Summary of Revision 1 to the J. M. Farley Nuclear Power Plant Unit 2
Ten-Year Inservice Inspection Program for ASME Code
Class 1, 2, and 3 Components

Page No./Description/Reason for Change

RR-9

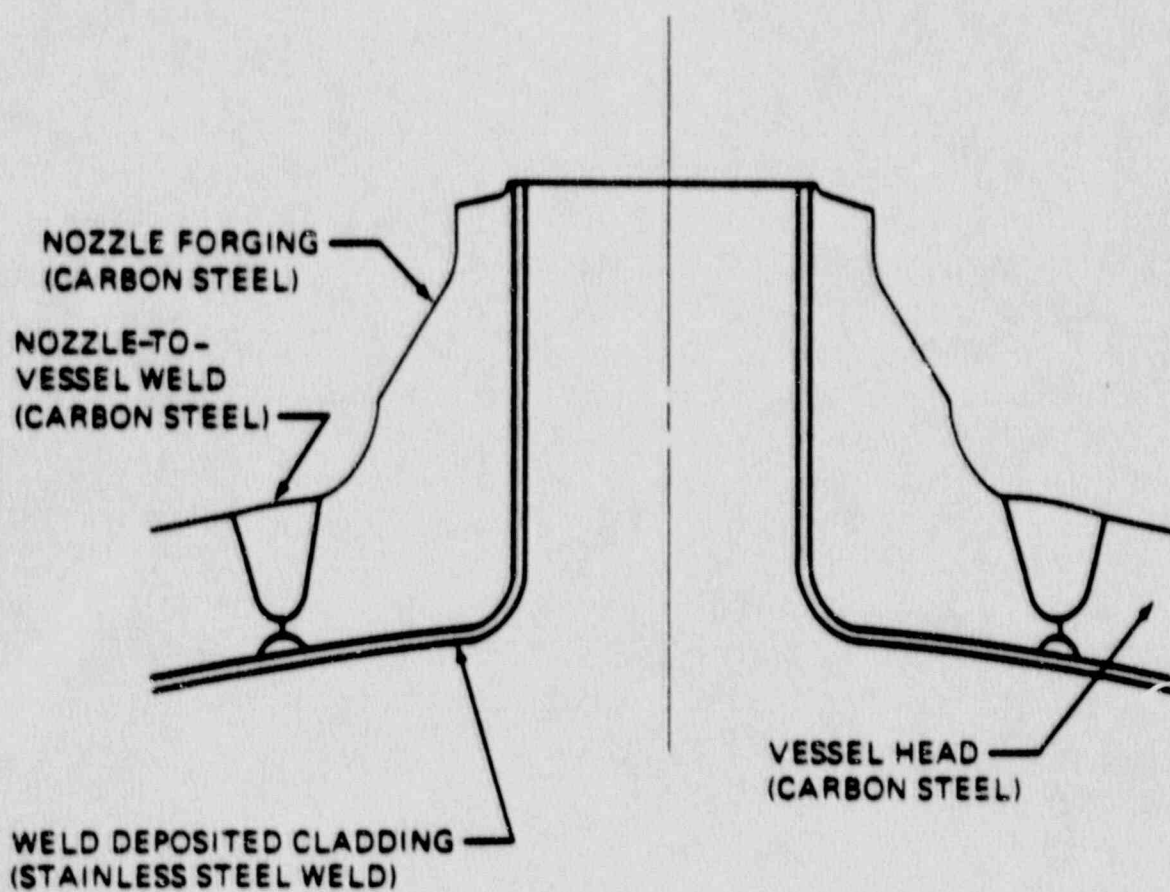
Component or
Relief Area: Volumetric examination of all nozzle-to-vessel welds in the pressurizer. Reference drawings APR1-2110, weld Nos. 1 through 6, and D-356354, sheet 2 of 3.

Requirement from
which Relief is
Requested: Item No. B3.110, Category B-D, Table IWB-2500-1 of ASME Section XI requires a volumetric examination of the nozzle-to-vessel weld. The applicable examination volume is shown in Figure IWB-2500-7(b) and includes 100 percent of the weld length.

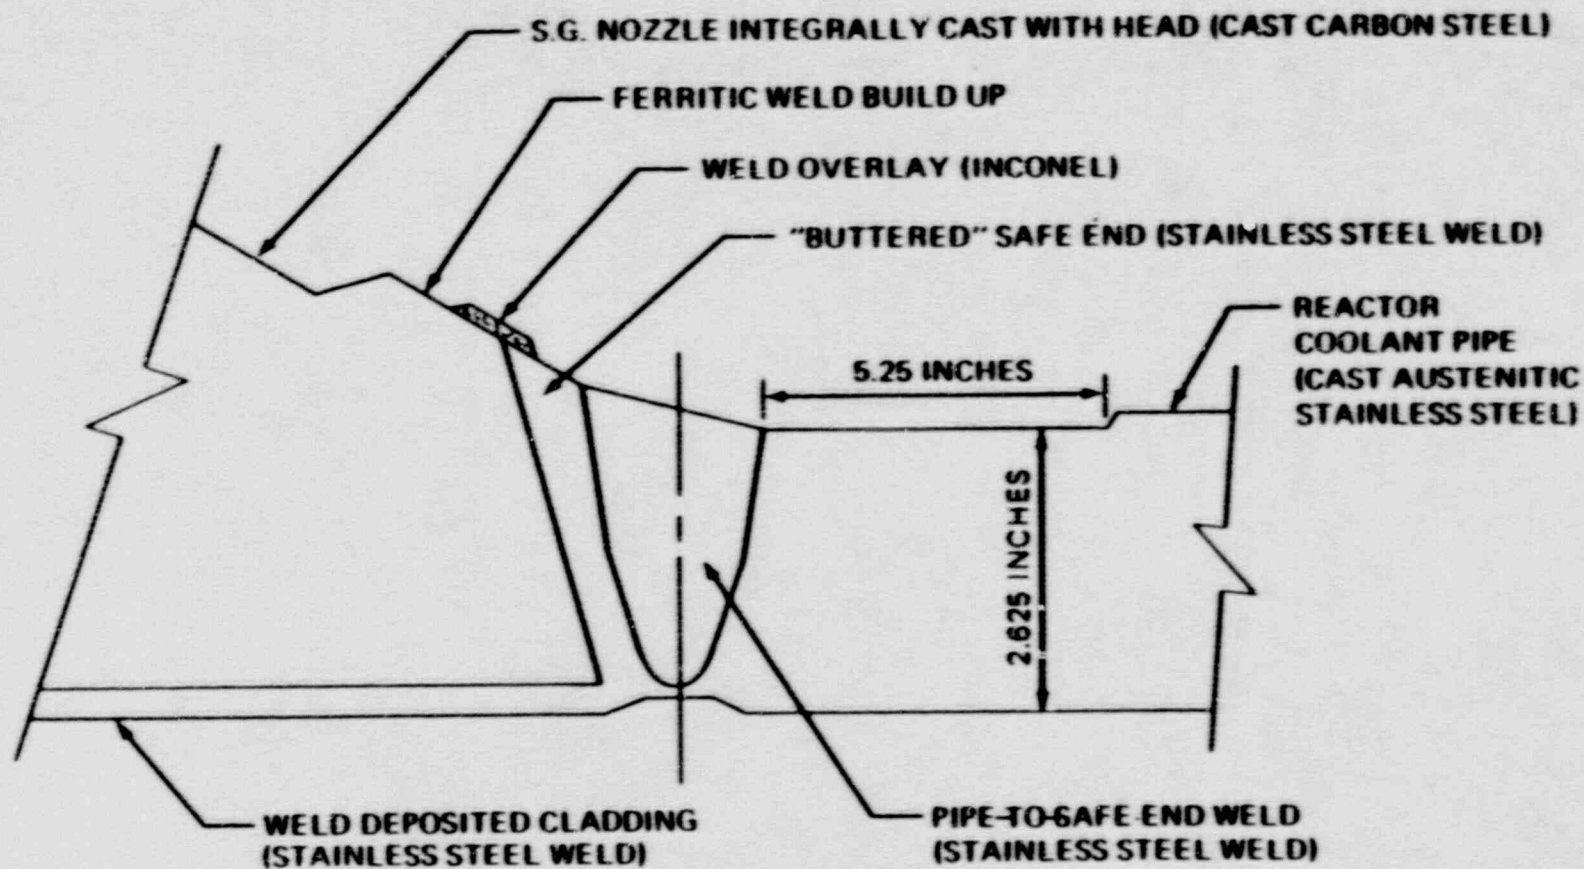
Volumetric examination of nozzle-to-pipe safe-end welds in all steam generators (primary side). Reference drawings APR1-4100, APR1-4200, and APR1-4300, weld Nos. 4DM and 5DM, and D-356354. sheet 1 of 3.

Item No. B5.70, Category B-F, Table IWB-2500-1 of ASME Section XI requires a volumetric examination of nozzle-to-safe-end butt welds in the steam generator. Applicable examination volume is shown in Figure IWB-2500-8 and includes 100 percent of the weld length.

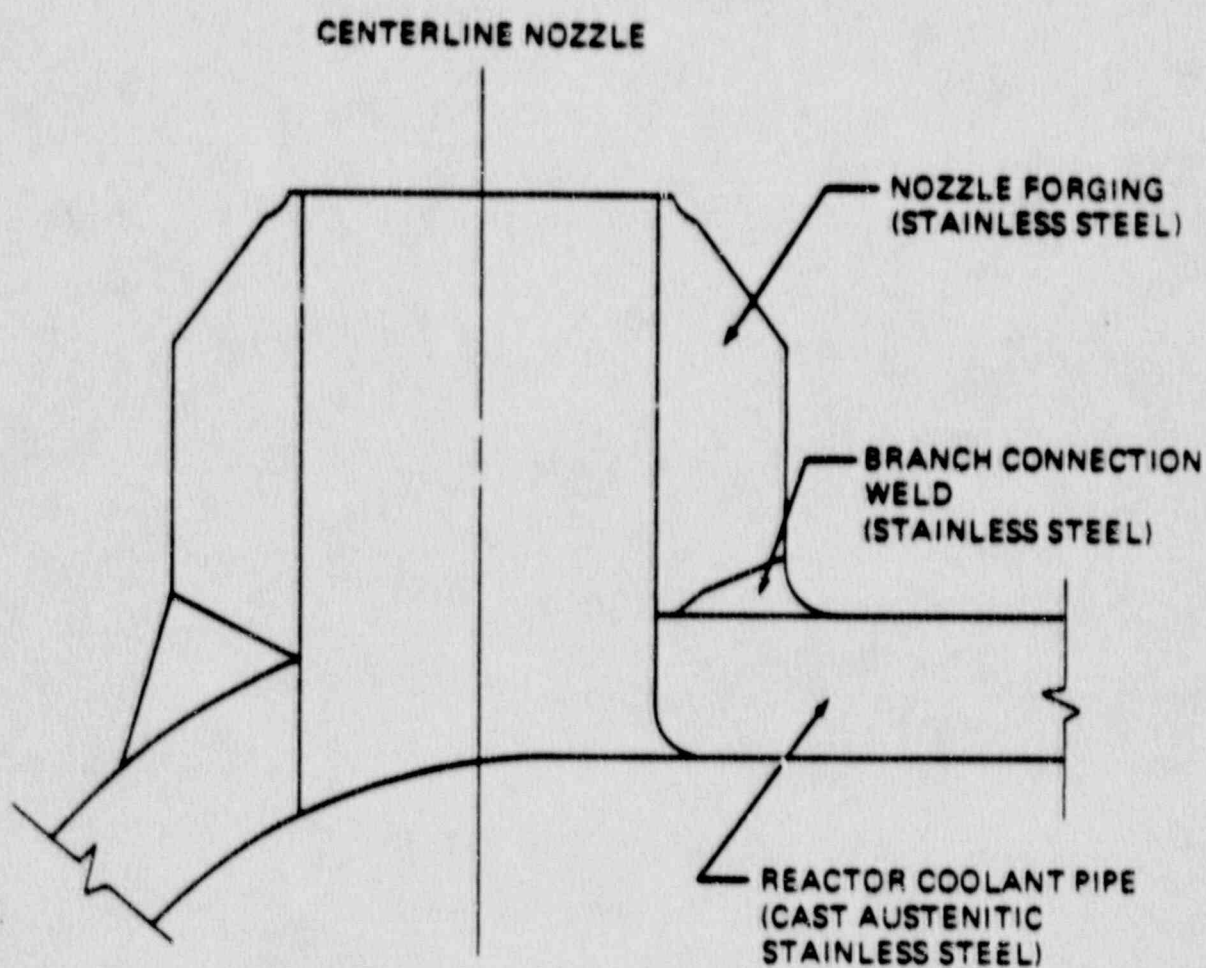
Volumetric examination of pressure retaining branch pipe connection welds in Class 1 piping. Attachment 13-2 lists all affected welds. Reference drawing D-356354, sheet 1 of 3.

Item No. B9.31, Category B-J, Table IWB-2500-1 of ASME Section XI, requires volumetric examination of branch pipe connection welds 4 in. nominal pipe size and larger. Applicable examination volumes are shown in Figures IWB-2500-9, -10, and -11 and include 100 percent of the weld length.

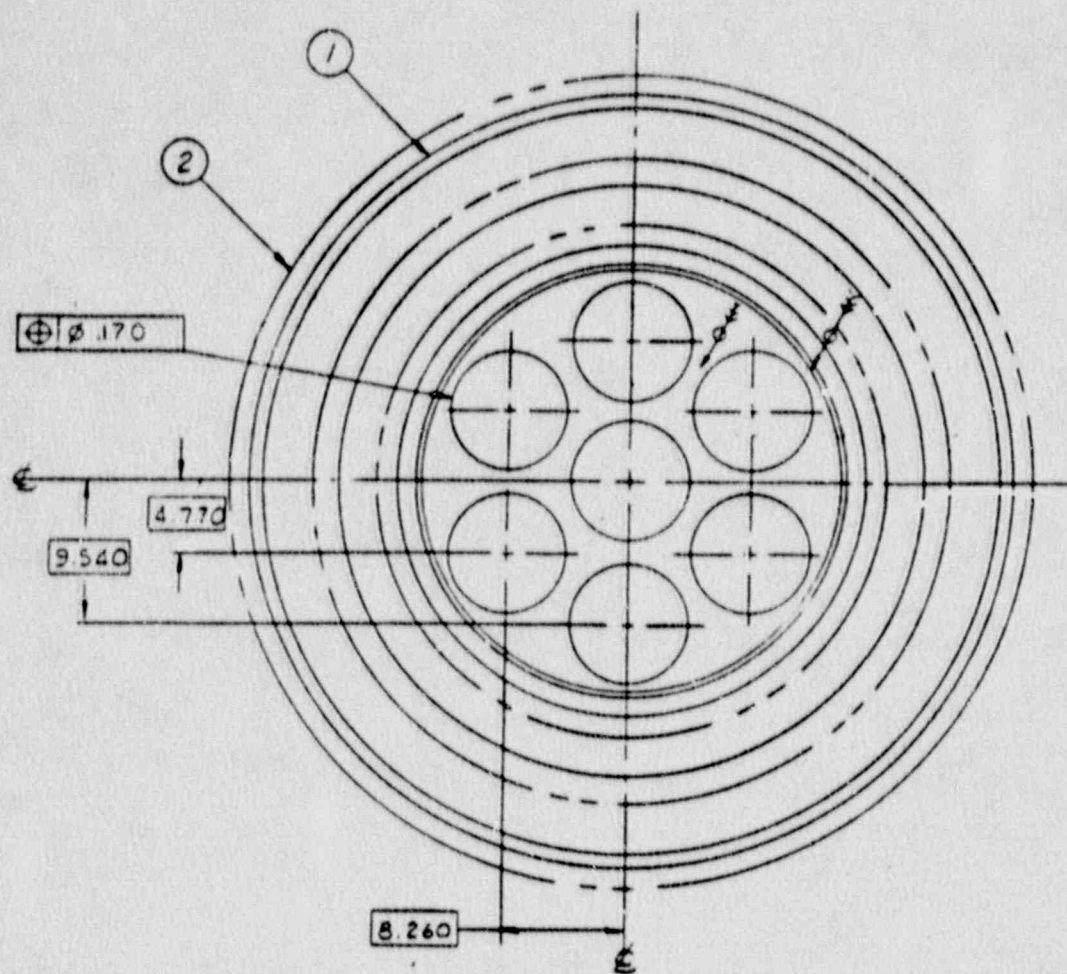
Volumetric examination of the nozzle inside radius section of the steam outlet nozzle on the Steam Generators. Reference drawing D-356350, sheet 1 of 3.

Item No. C2.22, Category C-B, Table IWC-2500-1 of ASME Section XI, requires a volumetric examination of the nozzle inside radius section for nozzles in pressure-retaining vessels. The required examination volume is shown in Figure IWC-2500-4.

The steam outlet nozzle is manufactured from a solid forging with seven (7) holes, each 8 1/2 inches in diameter, drilled through the forging (Attachment 2^a-1) to provide flow restriction. The geometry of this nozzle with the drilled flow restrictor holes does not have an inner radius and therefore no meaningful examination can be performed.

None.
